MONTGOMERY COUNTY HISTORIC PRESERVATION COMMISSION
STAFF REPORT

Address:	7334 Carroll Ave., Takoma Park	Meeting Date:	6/08/2022
Resource:	Contributing Resource Takoma Park Historic District	Report Date:	6/01/2022
Applicant:	Heritage Building & Renovation, Inc. Rick Leonard, Agent	Public Notice:	5/25/2022
Review:	HAWP	Tax Credit:	Partial
Case Number:	993419	Staff:	Dan Bruechert
Proposal:	Alterations to Rear Addition

Figure 5: Section drawing of the proposed window.

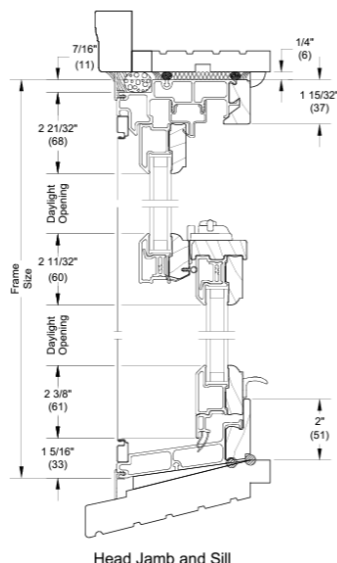
On the second floor, at the rear of the historic building, there are two vinyl casement windows installed in historic openings. The applicant proposes to remove these windows and install two six-over-one Marvin Elevate sash windows.

Staff finds the existing windows are not historic and their removal should be approved as a matter of course. Staff additionally finds that the six-over-one lite configuration is appropriate for the character of the building and surrounding district. Marvin Elevate windows have a fiberglass exterior and wood interior. Staff finds the proposed window has a thicker profile than most vinyl windows, but is much flatter than a wood window (see below) and is not appropriate in this application. Additionally, Staff has a question regarding the window lite division. The proposed window is available with grilles between the glass (GBG), simulated divided lite (SDL), and simulated divided lites with spacer bar (SDSL), but the application does not specify what method the proposed window will use to create multiple lites in the upper sash. Staff recommends the HPC add a condition to the HAWP approval that the new windows need to be wood or aluminum clad and have simulated divided lites with a spacer bar or have a one-over-one configuration. Final approval authority to verify that the condition has been satisfied can be delegated to Staff.

1. The proposed awning windows will be single lite and not have grilles between the glass; and,
2. The sash windows on the rear elevation need to be wood or aluminum clad windows and need to have simulated divided lites with a spacer bar or a one-over-one configuration.

PROPOSED NE ELEVATION

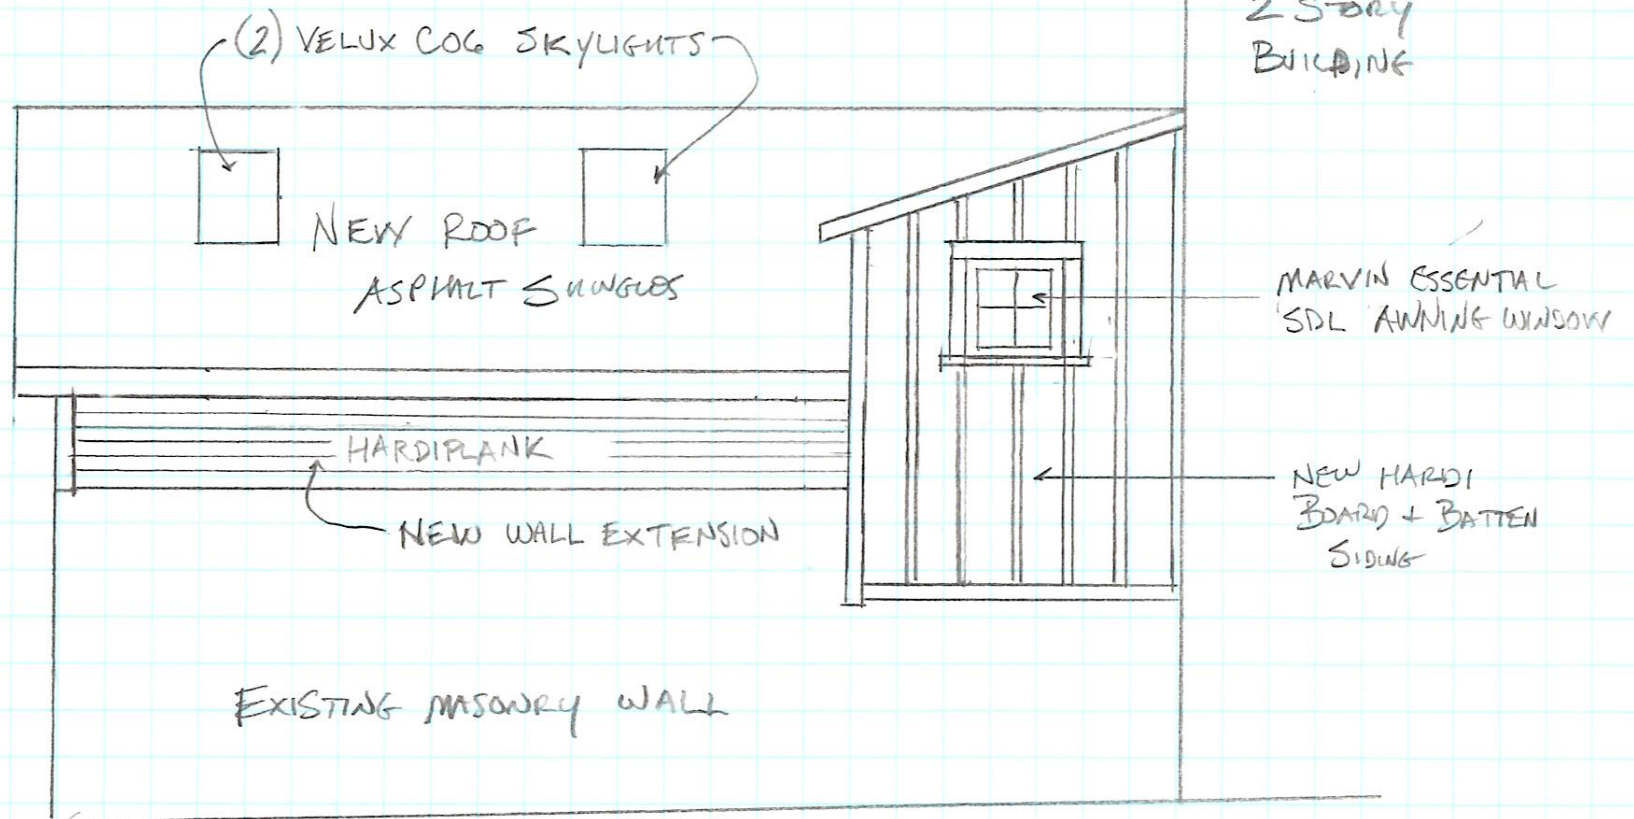
The existing roof is a shed roof that slopes away from Lee Ave. The roof rafters are too small for the span and the roof is sagging. The applicant proposes to remove the existing shed roof and install a rear-facing gable roof covered in asphalt shingles with skylights. The exposed gable end will be clad in fiber cement board and batten siding.

Staff finds the existing shed roof is not historic and its design is not architecturally significant; therefore its removal should be approved as a matter of course. Staff finds the proposed gable roof form is appropriate for the district, and its mass is compatible with the existing resource and the surrounding district. Additionally, Staff finds the asphalt shingles are an appropriate material. Finally, the proposed Velux skylights will be placed on the western roof slope, which is away from Lee Ave., so they will not be visible from the public right-of-way. Staff finds the new roof is appropriate for the building and character of the surrounding district and recommends the HPC approve the new roof under 24A-8(b)(2) and (d) and the *Design Guidelines*.

There is a small shed roof addition that connects the historic building to the larger one-story addition. The exterior of the small addition is covered in T1-11 siding that is failing. The applicant proposes to remove the existing siding and install board and batten fiber cement siding in its place.

Staff finds the existing siding is not architecturally or historically significant and it has begun to rot at the ends, therefore it should be removed. Staff finds that board and batten siding is not typically found on historic portions of contributing resources in the Takoma Park Historic District, but has been applied to non-historic additions. Staff finds the amount of siding, and its placement on a non-historic rear addition support the use of a substitute material in this instance under the *Design Guidelines*.

PROPOSED
REAR ELEVATION

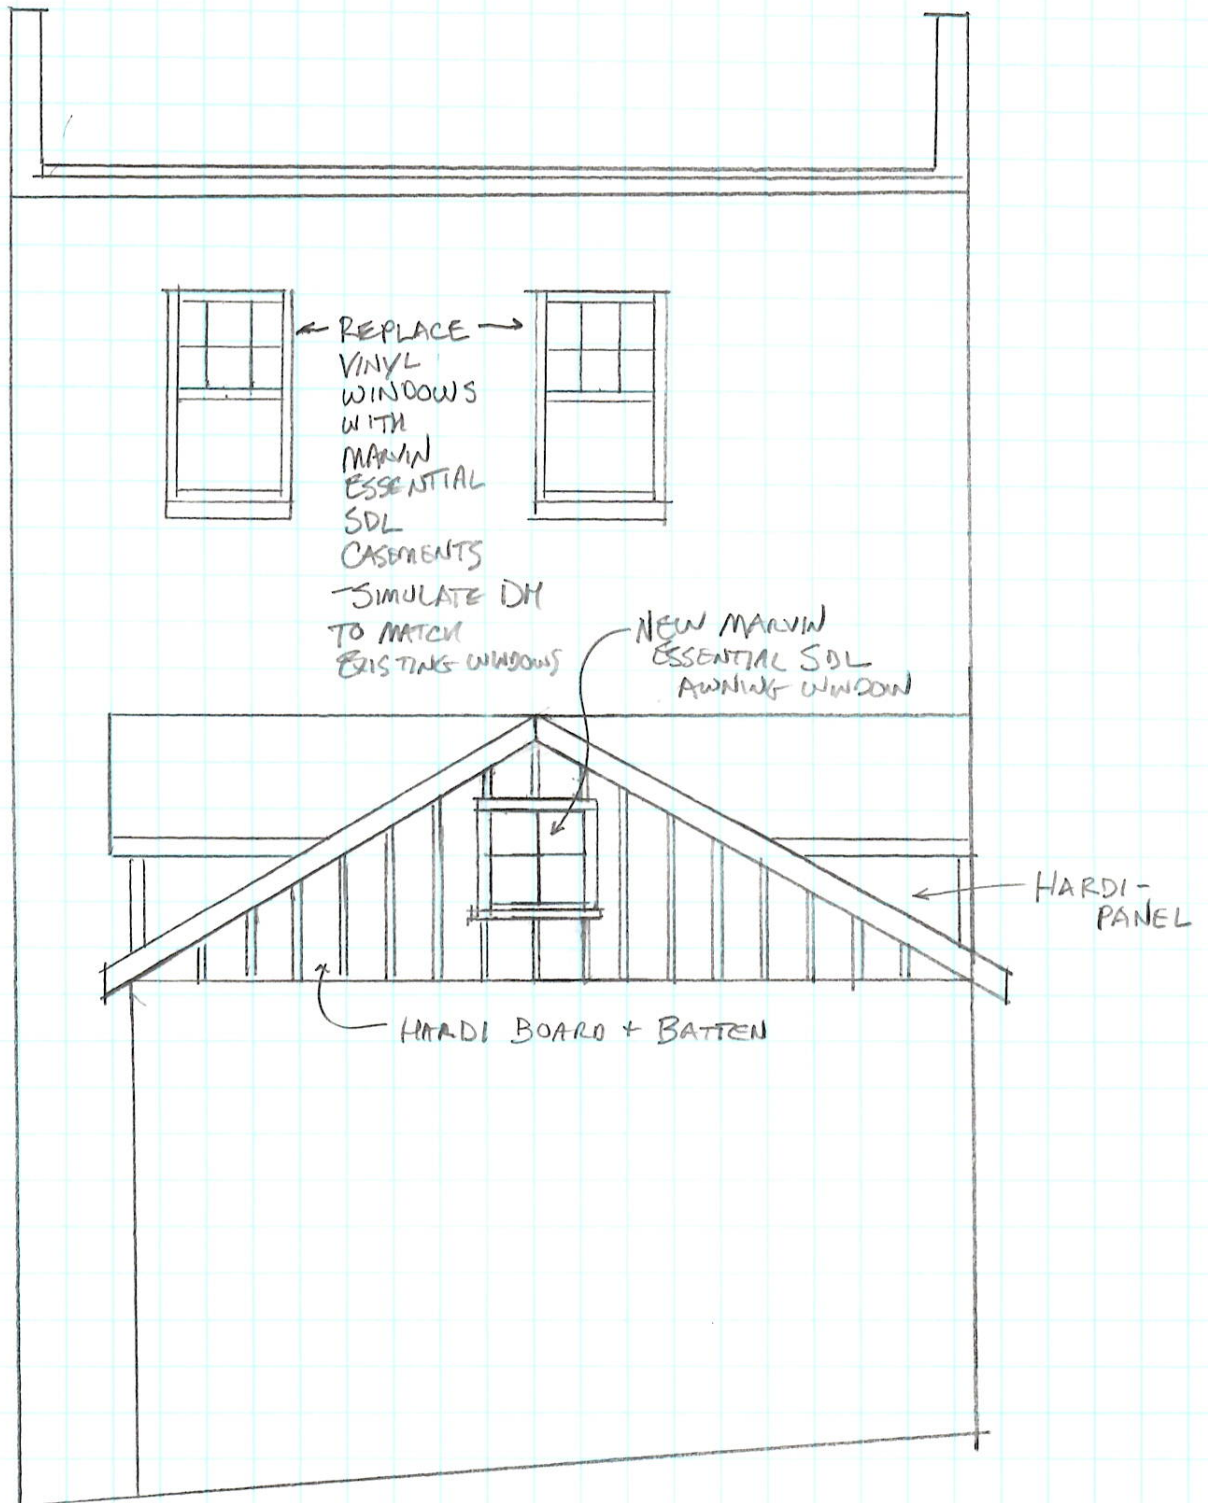
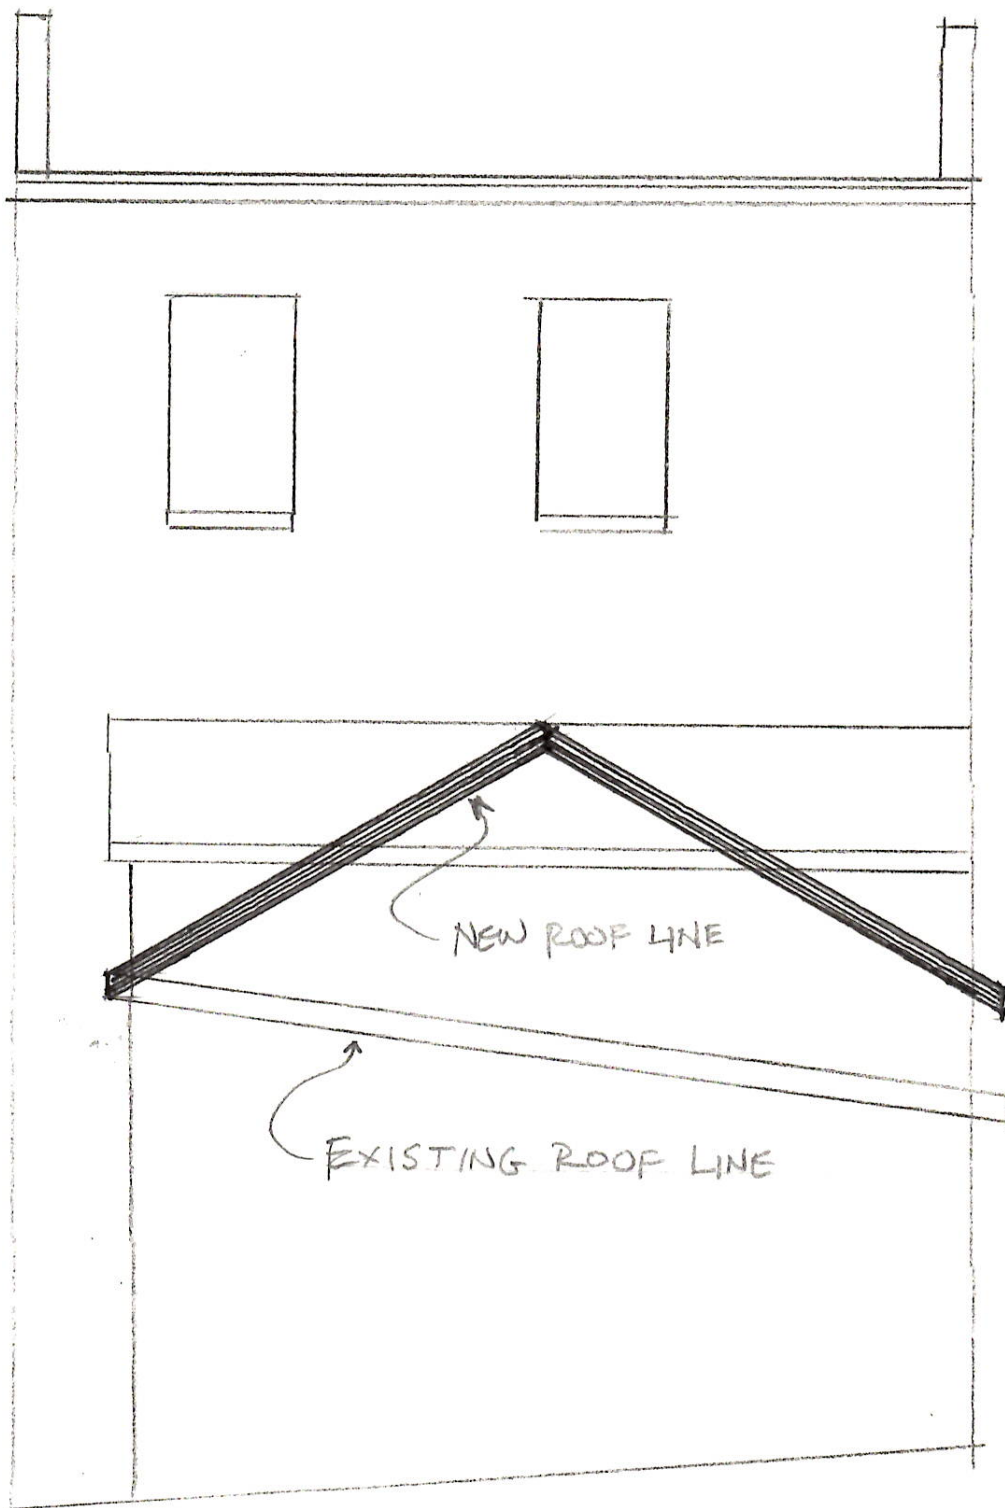
Staff also notes that the applicant proposes to construct a wall extension on the west elevation to accommodate for the new roof design. The extension will be sided in fiber cement clapboards and not parged, like the existing wall. Staff finds this portion of the addition faces away from the street and will

not be visible from the public right-of-way. Staff recommends the HPC approve this section as a matter of course.
